**MONTGOMERY COUNTY HISTORIC PRESERVATION COMMISSION**  
**STAFF REPORT**

<b>Address:</b>	7509 Carroll Ave., Takoma Park	<b>Meeting Date:</b>	08/16/17
<b>Resource:</b>	Contributing Resource <b>Takoma Park Historic District</b>	<b>Report Date:</b>	08/09/17
<b>Applicant:</b>	Gustavo Frech	<b>Public Notice:</b>	08/02/17
<b>Review:</b>	HAWP	<b>Tax Credit:</b>	Partial
<b>Case Number:</b>	31/06-17-CCC	<b>Staff:</b>	Dan Bruechert
<b>Proposal:</b>	Replace roof, doors, and other alterations

Figure 1: Front elevation of 7509 Carroll Ave. showing hipped roof front porch

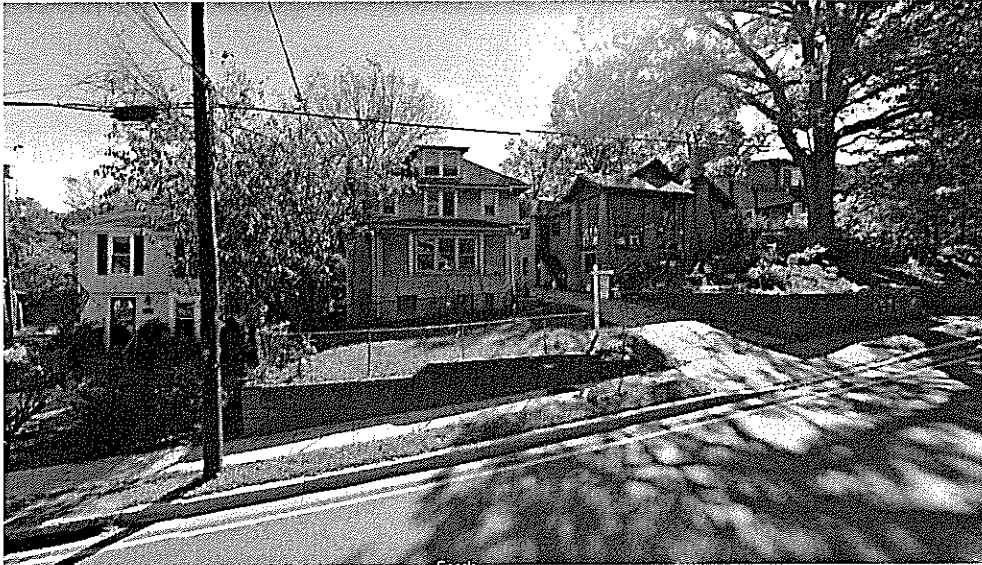
The applicant is proposing to replace the degraded three-tab asphalt shingles on the roof and dormer roof with shingles that match the appearance and materials. The applicants also propose to change the roofing material over the front roof from asphalt shingles to a metal roof. The metal roof will be a clip-in, rather than a field-turned roof that will have a standing seam appearance. The attached cut sheet (Circle 46) shows the profile for the proposed roofing is consistent with a field-turned metal roof. This element will have a minimal visual impact on the surrounding district and Staff is generally supportive of this proposal, as a standing seam metal roof would be appropriate on an American Foursquare in the 1920s (see the attached photograph below).

PROPOSED SITE PLAN  
NOT TO SCALE

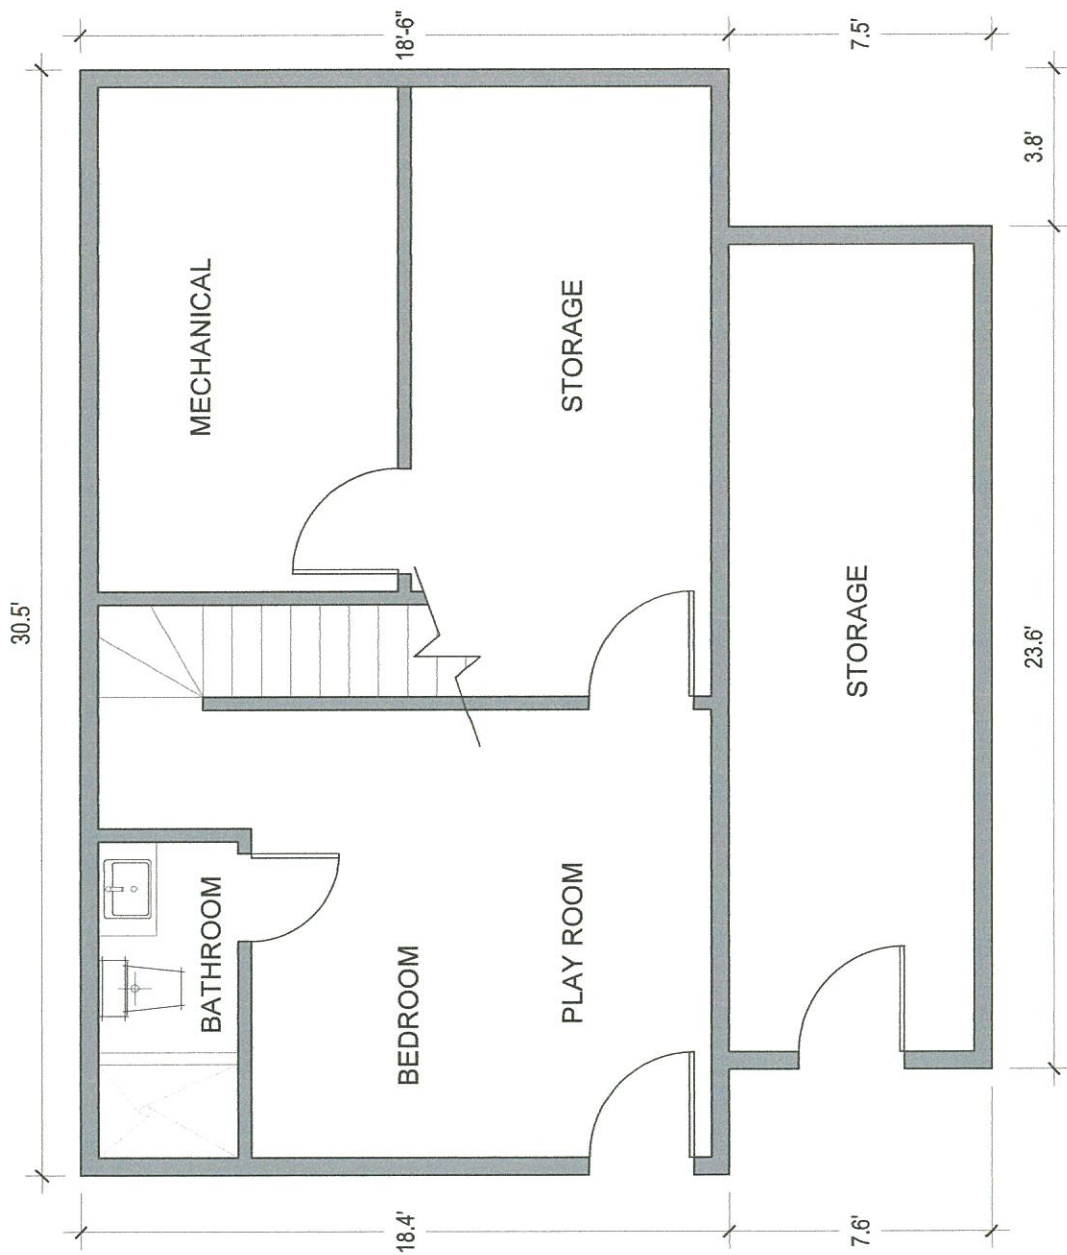
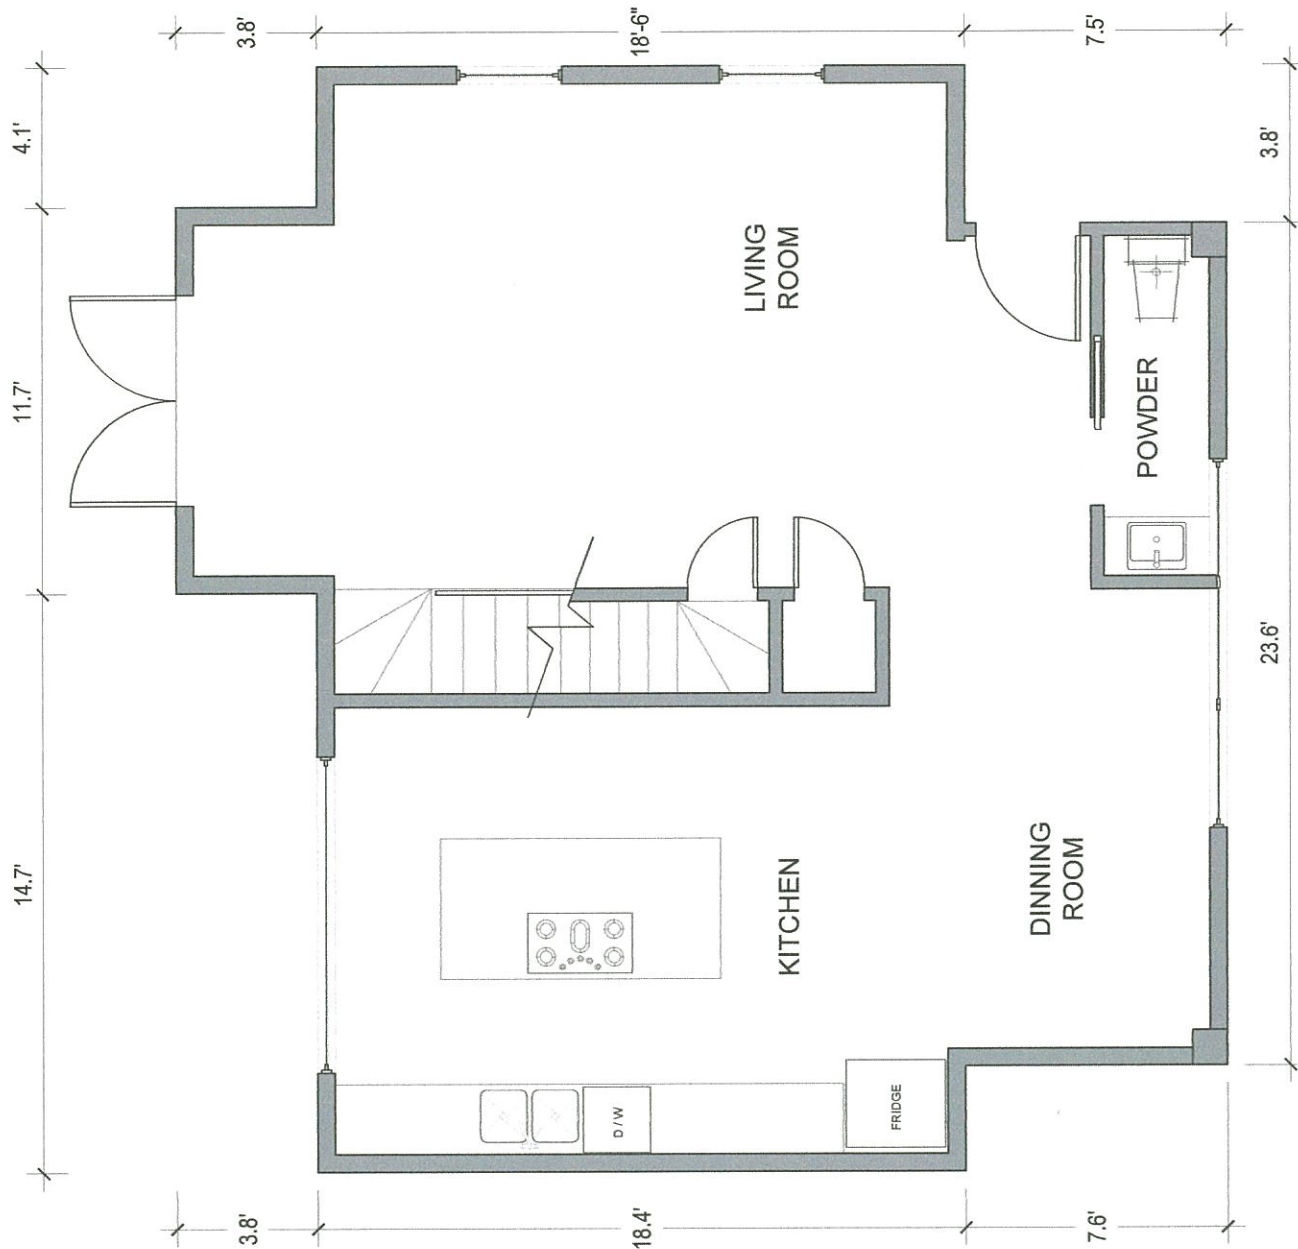
The applicant has proposed to introduce a front walkway from the sidewalk so that residents and guest do not need to walk up the driveway to access the house (see the attached proposed site plan). Staff agrees that some type of walkway in this location is consistent with the surrounding district and would not have a negative impact on the historic character of the house. However, the applicant did not provide material specifications or dimensions and staff does not have sufficient information to make a recommendation to the HPC on this element. Because undertaking this rehabilitation project is not contingent on this single element, Staff recommends that the applicant be required to re-submit a HAWP for the walkway for HPC's review at a future meeting.

PROPOSED SOUTH ELEVATION

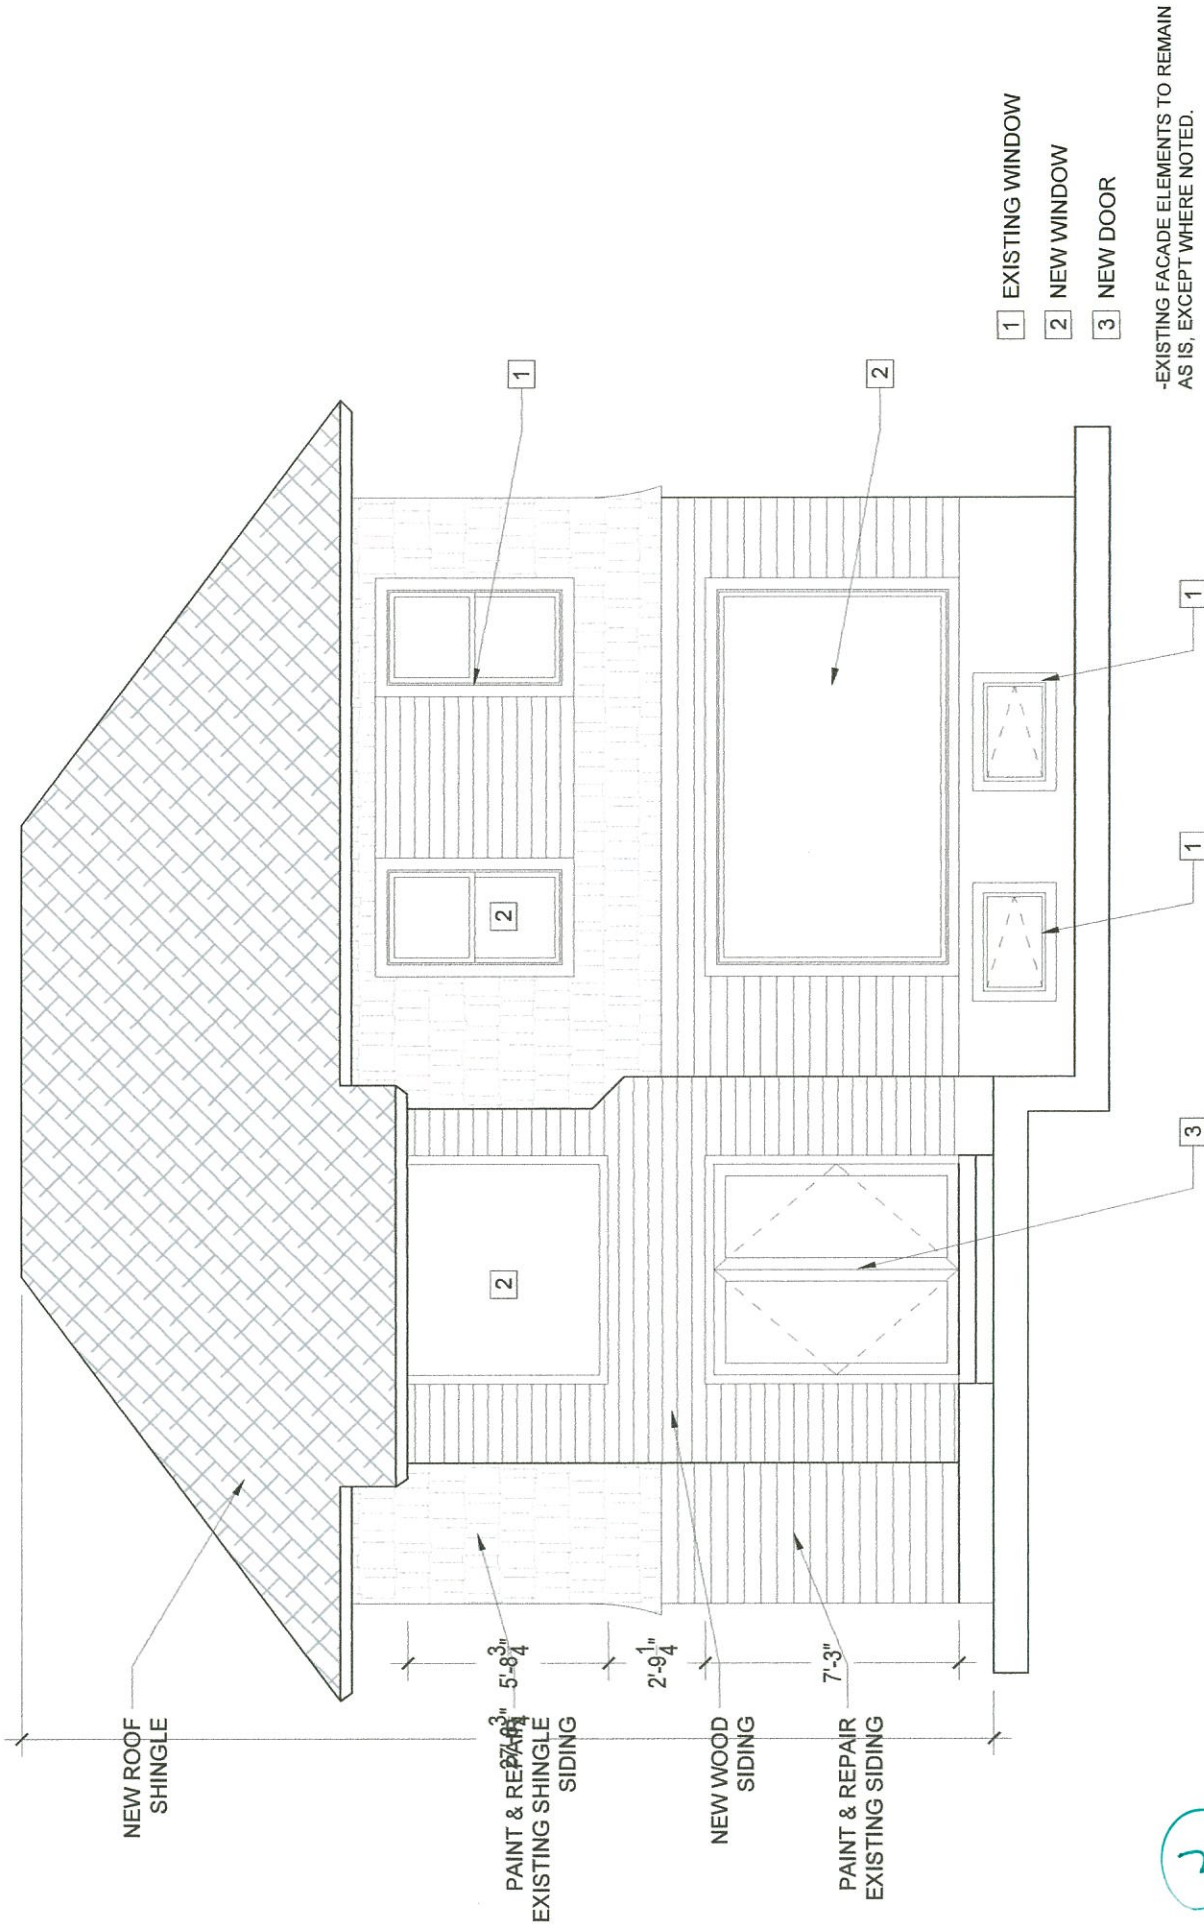
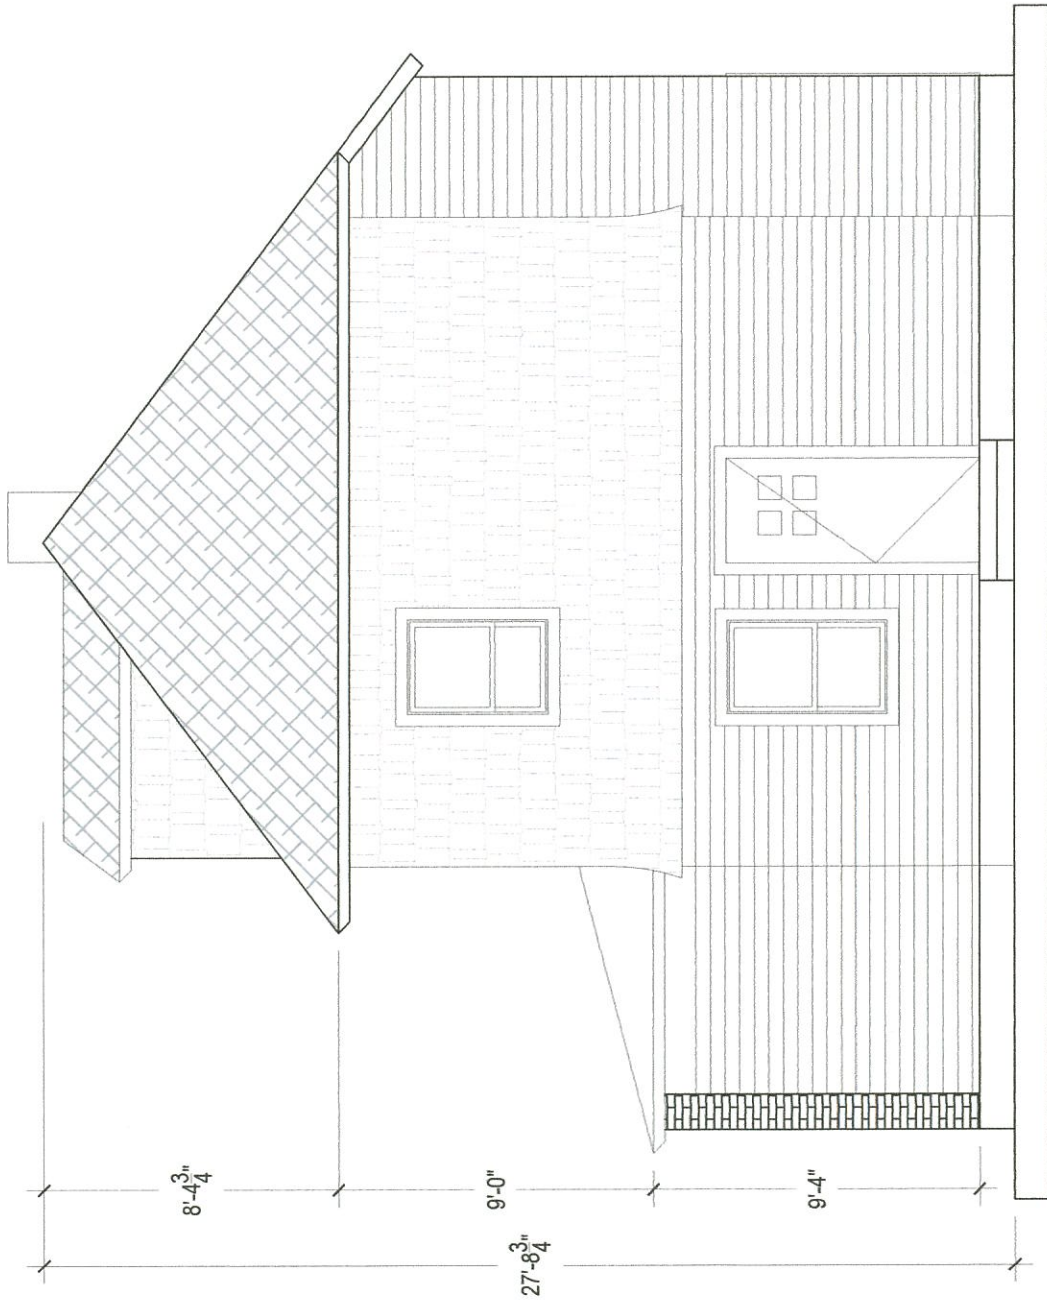
The applicant is proposing several changes to the fenestration for the rear of the building. Most significantly, the applicant is proposing to introduce two picture windows, one on the first floor and one on the second floor of the south façade. The south façade is part of the historic mass of the building, however it has been modified over time and is a secondary elevation that is not visible from the public right-of-way.

Currently, the south façade has a single non-historic door and non-historic window on the first floor with two non-historic windows on the second floor; there are also two below-grade non-historic basement windows on the south façade. The applicant is proposing to remove the two second floor sash windows and replace them with Andersen 200 Series windows. As these windows are not historic and have degraded, Staff supports their replacement. Additionally, the applicant is proposing to replace the two non-historic, below-grade windows with windows that match the opening size. This change is not visible from the public right-of-way and will only be visible from the rear yard. All of these changes are not visible from the public right-of-way and should be approve as a matter of course (per Design Guidelines).

The other changes proposed for the rear of the house are more significant, however, they are not visible from the public right-of-way and should be approved as a matter of course. The applicant is proposing to remove the non-historic door and install a pair of full-lite French doors. This new feature will not have an impact on the surrounding district and is replacing a modern feature. The applicant is also proposing to remove the fist-floor sash window and replace it with a large picture window. Additionally, the applicant is proposing to install a large picture window on the second floor above the proposed French doors. Both of these windows are modern in their design and are not in keeping with the Craftsman design elements found on the house. However, these changes will not be visible from the public right-of-way and will not have an impact on the

surrounding district. These changes appear to comply with 24A-8(b)(2) and the Takoma Park Historic District Design Guidelines. Staff supports the proposed changes to the south façade.
